<div>MATRIX</div> <div>Service Bulletin</div> <div>Announcing Matrix ClimbMill Improvements</div>		
Effective Date: April 16, 2015	Models Affected: C-3X-F (CS21), C-5x/7x-01-F (CS17/CS22/CS23/CS24)	Bulletin Num.
Prepared by: Eric Chen		NB-1505004

ClimbMill Improvements

Case 8: Side cover - Location hole on side covers is removed

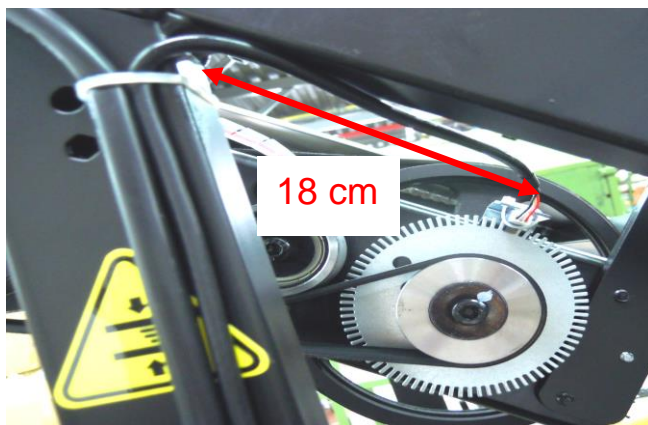
Old – Side cover with location hole

New – Side cover with location hole removed

Case 12: Drive set – Fan/DC brake wire location modified for easier repair

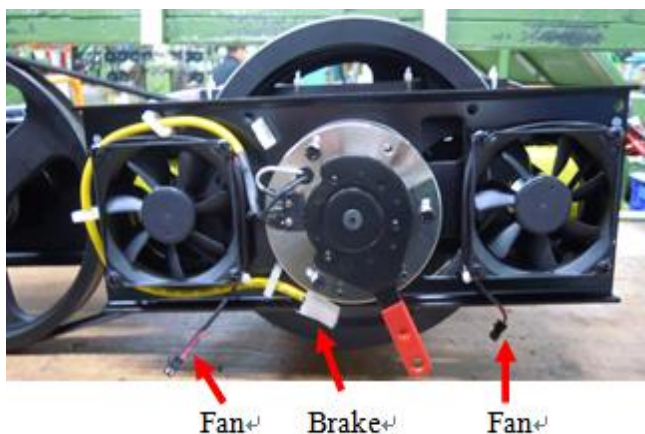
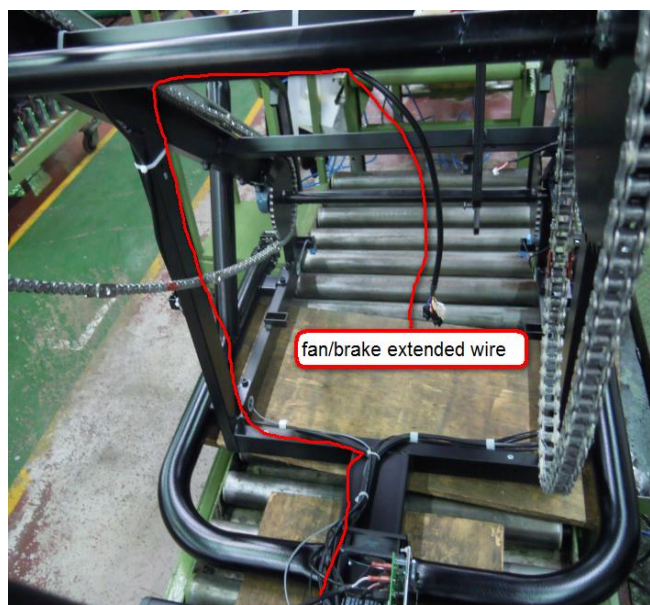
Old – Difficult to perform repair

New – Easier to unplug and fix fan/brake wire

Case 13: Drive set – Brake power cable tube color changed to yellow so it's easy to distinguish

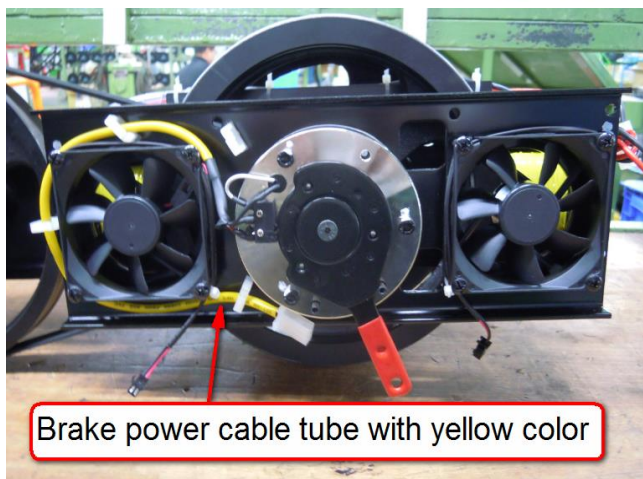
Old – Black brake power cable

Brake power cable tube with yellow color

New – Yellow brake power cable

Case 14: Drive set – Fixing plate screw type modified for easier disassembly

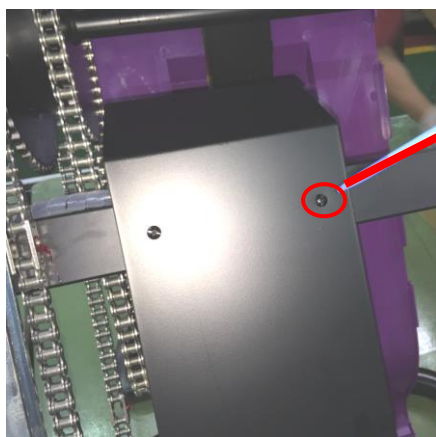
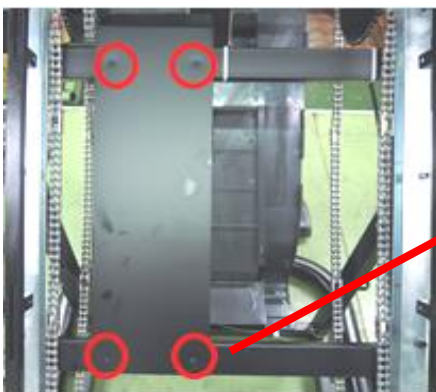
Oval crisscross screw

Old – Oval crisscross screw

Socket head screw

New – Socket head screw

Case 15: Hand grip – Hand pulse wire location changed to prevent wire damage

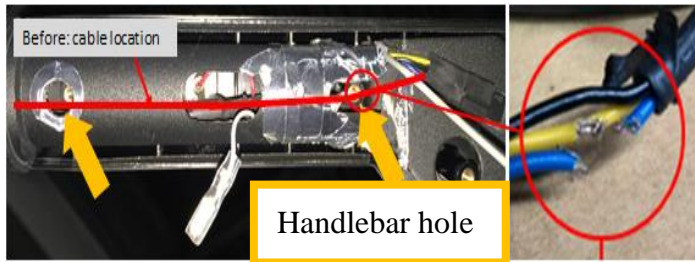
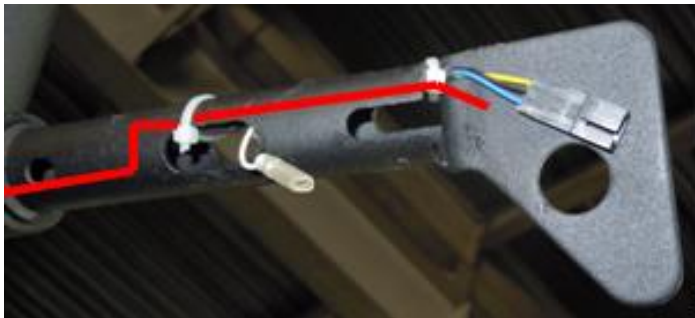
- There is no cable tie to keep the hand pulse wire in place.
- Hand pulse wire goes over the handlebar hole. The wire would be damaged when hand grip cover is assembled.

- Add two cable ties to fix the hand pulse wire in place.
- Hand pulse wire doesn't go over the handlebar hole.

Case 16: Hand pulse wire connector would become loose

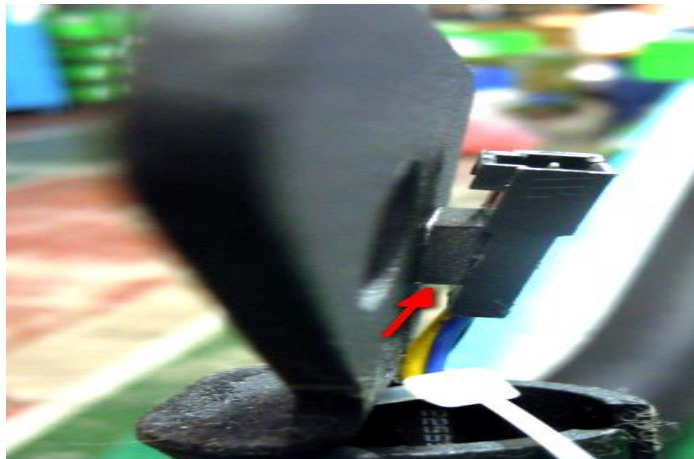
Old – Foam tape with 1.5 mm thickness

New – Foam tape with 2.5 mm thickness to prevent wire connector from becoming loose

Case 20: Guide rail – Guide rails are galvanized to be rustproof

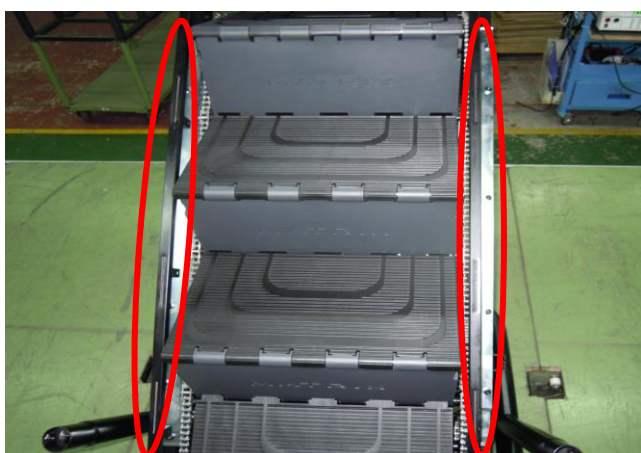
Old – Guide rail with anti-rust grease

New – Galvanized guide rail

Case 21: Frame IR – Screws are changed to galvanized socket head screws (easier to disassemble and rustproof)

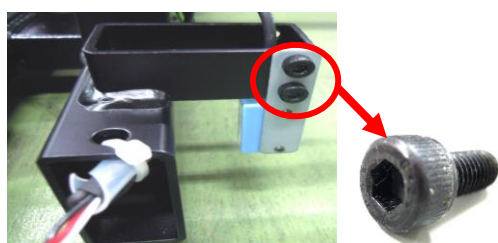
Old – Oval crisscross screw

New – Galvanized socket head screw
